# CITY OF SAN ANTONIO

Re: **The Village at Quarry Market**

MX / MDP # MX-834

The City Staff Development Review Committee has reviewed **The Village at Quarry Market Mixed Used District (MXD)/ Master Development Plan (M.D.P.) # MX-834**. Please find enclosed a signed copy for your files. Your plan was accepted, however please note the following:

**THE VILLAGE AT QUARRY MARKET**  
**MASTER DEVELOPMENT PLAN / MIXED USE DEVELOPMENT**

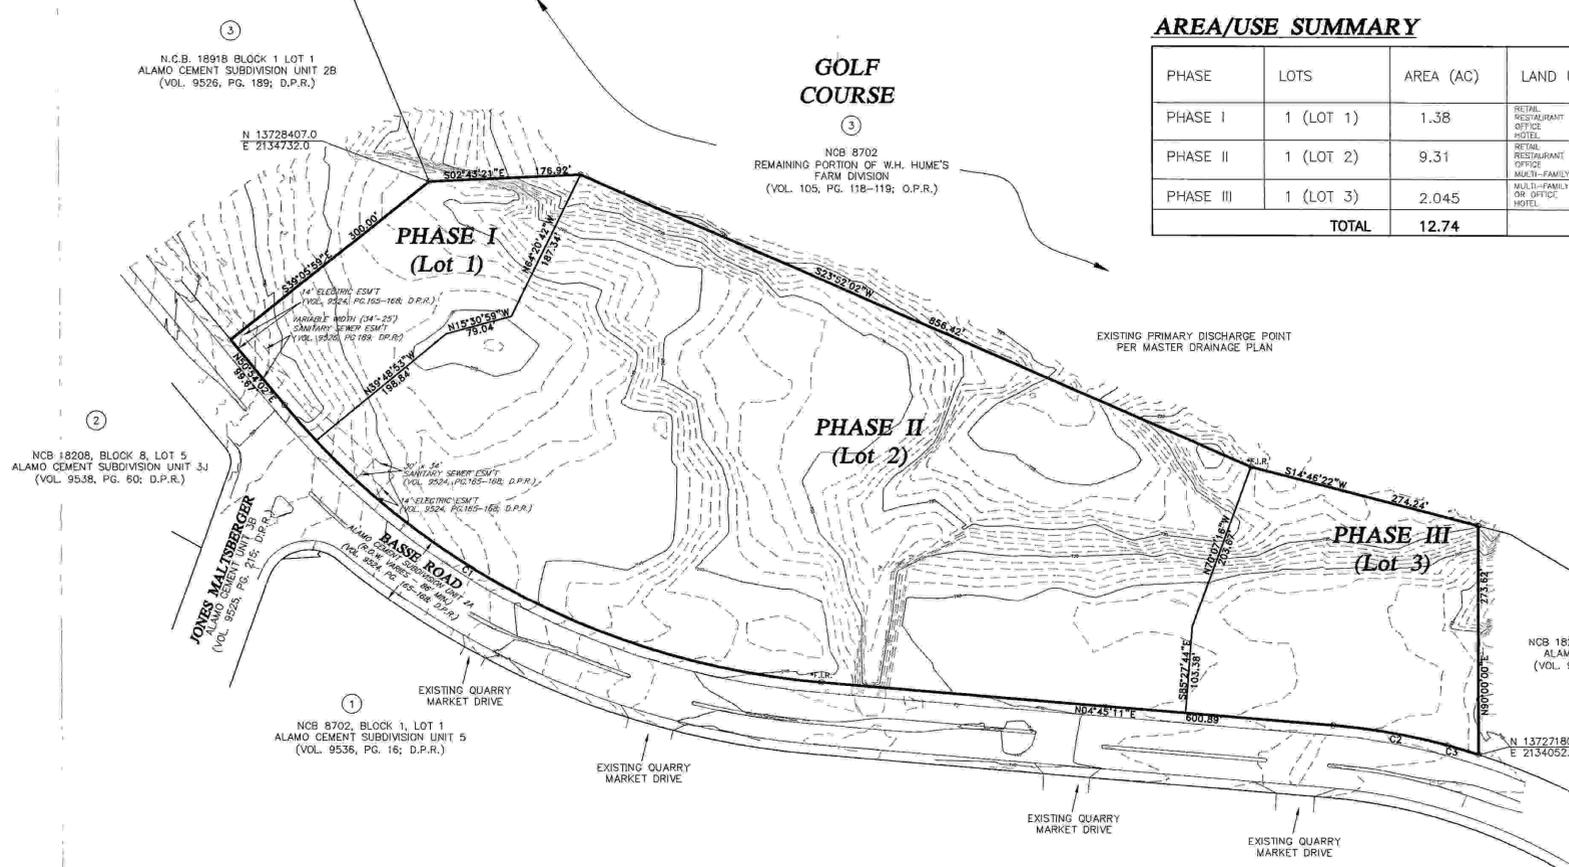
- In consideration of public safety and convenience, excessive grades by reason of topography should be avoided in street layouts and arrangements.
- Any access and R.O.W. issues along state facilities will need to be resolved with the Texas Department of Transportation (TXDOT). For information about these requirements you can contact TXDOT at 615-5814.
- As part of their conditional approval the **Parks and Recreation Department** has cited the following will have to be met prior to any final plat approval:

A 1.2 acre park will be developed along the eastern side of the property. 2.5 acres of credit will be awarded for the inclusion of swimming pool with 2500 SF of surface area and meeting the description detailed in Table 503-4. Park to be developed in conjunction with Phase Two of the project.

The park shall include the following:

1. Three picnic areas to include tables, benches, trashcan, grill, and cement slab.
2. A minimum of two park benches shall be installed.
3. Within the Park, the applicant must plant fifteen trees. Each tree must have a minimum caliper of three inches. Applicant may plant a minimum of two of

thefollowing species: Cedar Elm, Live Oak, Red Oak, Chinquapin Oak, or Monterrey Oak. Trees are to be guaranteed for three years from date on planting.

4. A continuous walking trail with a minimum width of 6' feet, with a minimum length of 0.25 miles. Surface to be decomposed granite, asphalt, or concrete.

**Development Services, Engineering Section (TIA)** has indicated as part of their conditional approval, The following on-site improvements, as well as, improvements along the project limits are necessary and shall be provided by the developer, on and before the completion of the West Rim at the Quarry Development, at no cost to the City of San Antonio:

- All signal modifications as described in the TIA shall be reviewed and approved by Public Works – Traffic Engineering UDC 35-506 (k) Traffic Signals.

- Extend northbound left turn lane to provide 250 feet of storage on Basse at Jones Maltsberger to provide added capacity on Basse.
- Existing eastbound lane configuration on Jones Maltsberger shall be converted to a left, shared left and thru, and exclusive right turn to provide a means to access West Rim at the Quarry. Requires modification of signing and pavement markings. All marking modifications shall be approved by Public Works – Traffic Engineering.

- Westbound driveway configuration at Jones Maltsberger and Basse shall consist of two outbound lanes, one configured as shared left and thru and one as a right turn only. All marking modifications shall be approved by Public Works – Traffic Engineering.

- Alamo Quarry Driveway and Basse intersection: Construct 100 – feet of right-turn deceleration lane on northbound Basse in accordance with City of San Antonio requirements.

- Modify existing median in order to provide 50 feet of storage on southbound Basse at Driveway 2 (south most driveway). This will provide added capacity on Basse.

- Make the exit at roundabouts wide enough to accommodate both left and right turn lanes.
- Driveway throat lengths shall comply with City of San Antonio UDC requirements, to facilitate the safe and efficient flow of traffic.
- All access driveways shall comply with UDC 35-506 (r) (8) Alignment.
- All access driveways shall provide clear sight distance along Basse Road to provide adequate obstruction free viewing distances for approaching traffic. All signage, landscaping, and improvements shall be selected and located so as to not block these clear sight distance areas.

It should be understood that the submitted TIA is a conceptual plan and therefore this document does not represent an approval for the internal site plan. Site circulation is important for this proposed development. Reduced number of driveways and cross access from the retail stores to both Jones Maltzberger/Basse and Alamo Quarry/Basse signalized intersections is encouraged in order to provide safe and efficient movement of traffic to and from, within and past, the proposed development, while minimizing the impact to non-site trips.

TIA Reviews recommends that this development provide direct access from apartments/retail complex garages to both Jones Maltzberger/Basse, and Alamo Quarry/Basse signalized intersections. This will reduce on-site circulation along retail parking.

- This development will need to comply with tree preservation ordinance #85262. For information about these requirements you can contact **Tree Preservation** at 207-8265.
- It will be expected that you will plat all of the property depicted in your Mixed Used District (MXD)/ Master Development Plan (M.D.P.) to include floodplains, drainage areas and open space.
- I would encourage you to work closely with the school district, so that they can plan accordingly.
